ADDENDUM NUMBER ONE (1)

Project: 24071 Smith County School District Career Center Addition & Renovations
25039 SCSD Administration Renovation & Addition

FROM: Dean Architecture, P.A.
661 Sunnybrook Road, Suite 140
Ridgeland, MS 39157
(601) 939-7717

ADDITION OF STOOP, HANDICAPPED RAMP AND RAILINGS TO EXIT AT DOOR #100C
 DWG. NO. **R-1/A101**

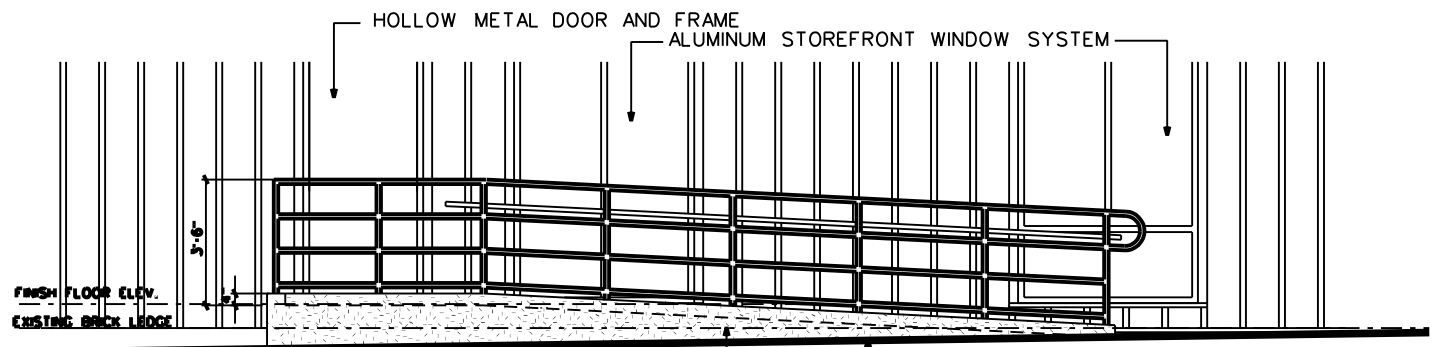
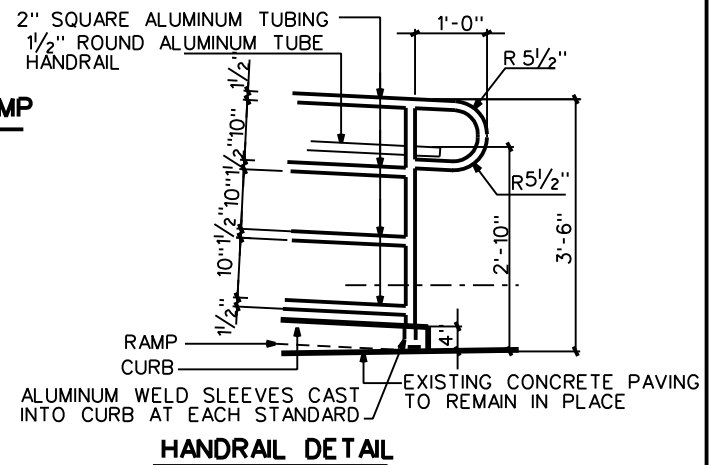
Item #4: SHEET A101 - OVERALL FLOOR PLAN, add the following:
Add revision drawing R-1/A101 that shows the addition of solid concrete handicapped ramp and stoop with aluminum tube railings to the exterior of door #100C.

CONCRETE STOOP AND RAMP POURED ON TOP OF THE EXISTING CONCRETE PAVING THAT IS TO REMAIN IN PLACE. SET A GRID OF 1/2" DRIFT PINS DRILLED AND EPOXYED INTO THE EXISTING CONCRETE PAVING AT 2'-0" O.C. EACH WAY TO ANCHOR STOOP AND RAMP TO THE EXISTING PAVING THAT IS TO REMAIN IN PLACE

ADDITION OF STOOP, HANDICAPPED RAMP AND RAILINGS TO EXIT AT DOOR #100C
 DWG. NO. R-2/A201

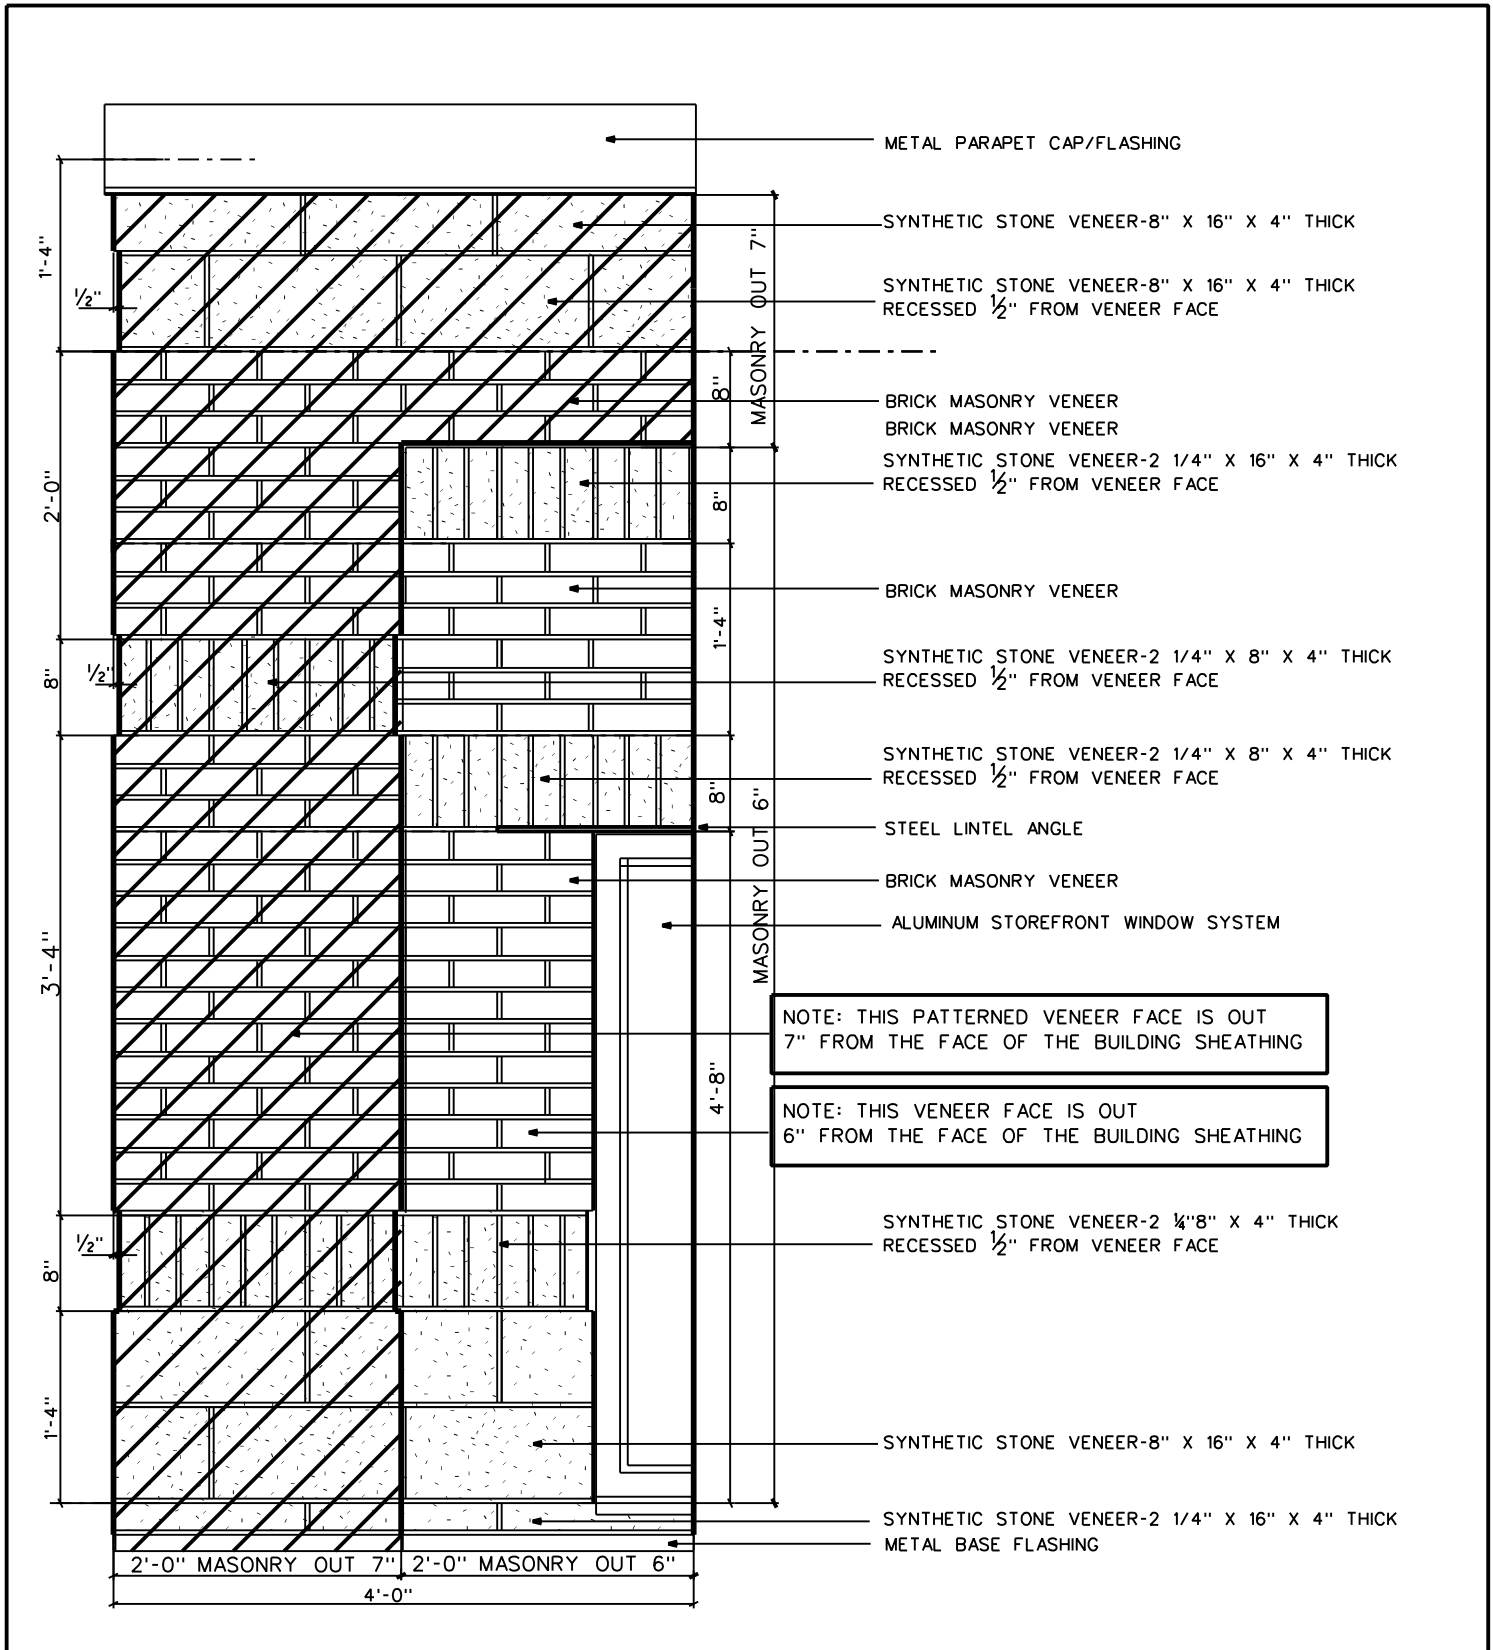
- Item #9:** SHEET A103 - FLOOR PLAN, add the following:
On the exterior wall, at the old laundry room, there is a hole in the wall where a dryer vent used to be and has been removed sometime in the past. The owner wishes to have this patched and closed so rainwater cannot get into the building. The General Contractor is instructed to remove and replace the existing exterior wall panel as needed to perform a patch over this area. Cut and remove as much of the existing wall panel as needed to install a new piece of wall panel that will close up this condition. The General Contractor may use salvage metal siding that is removed from the renovation exterior walls to provide material for this patch work.
At the southeast corner of the gymnasium portion of the building a similar condition in the exterior wall exists where a hole was cut into the exterior wall panel for some past maintenance. The owner wishes for this hole to be patched and closed in the same similar manner as described above. See addendum drawing R-2/A201 included with this addendum.

NOTE:
 PROVIDE FOR THE REMOVAL AND PATCHING OF THE EXISTING EXTERIOR METAL SIDING PANELS WHERE THESE HOLES IN THE WALL OCCUR. UTILIZED SALVAGED SIDING MATERIAL FROM THE RENOVATION PORTION OF THE PROJECT TO PROVIDE WHAT IS NEEDED TO FORM THIS PATCH WORK.

EXTERIOR WALL DETAIL
ADJUSTMENTS

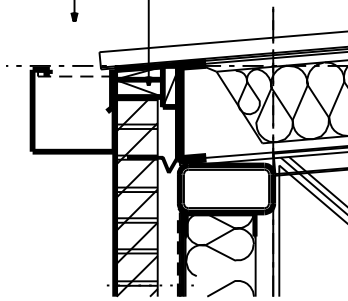
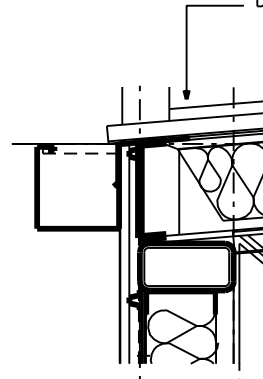
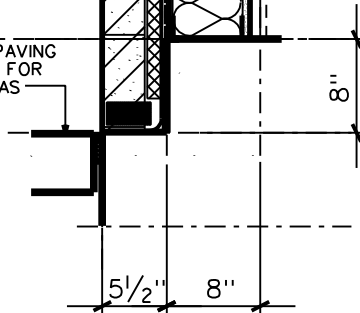
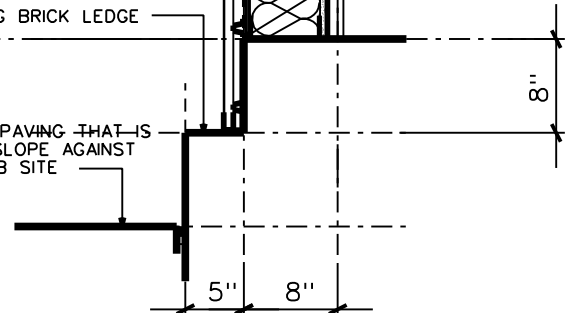
- Item #20:** SHEET A301 – WALL SECTIONS, add the following:
Add revision drawing R-2/A301 to the bidding documents to show adjustments to dimension and framing the eave and sill of the exterior walls of the existing building and the building addition.

THIS ADJUSTMENT WILL APPLY
TO DETAILS FOR ALL EXTERIOR
WALLS OF THE ADDITION AREA

THIS ADJUSTMENT WILL APPLY
TO DETAIL 1,2,6/A301
